CITY OF FORT COLLINS

ADDENDUM No. 1

Bid #5810

LEAD ABATEMENT AT POLICE FIRING RANGE

**ADDITIONAL
REMOVAL AREAS**

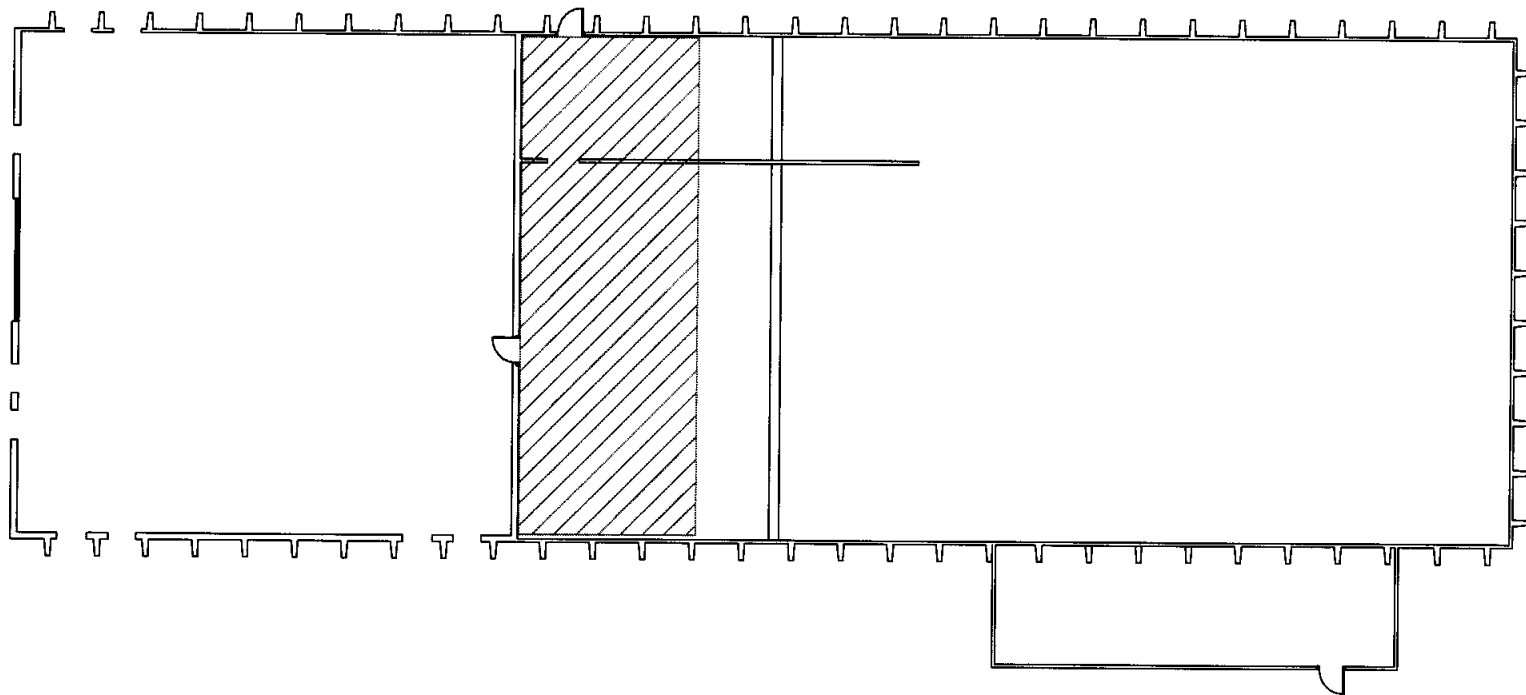
The additional materials to be removed are described in the section below and shown on supplemental drawing located in Appendix A. The contractor is responsible for determining exact quantities of materials to be removed.

In the firing range portion of the building where decontamination is to take place, all the 2' x 4' lay-in ceiling tiles including the 2' x 4' tiles located behind (to the south of) the shooting booths are to be removed and properly disposed. These materials will require management and disposal as hazardous waste. The contractor is responsible for proper material containerization, labeling, manifesting, and transportation functions related to disposal.
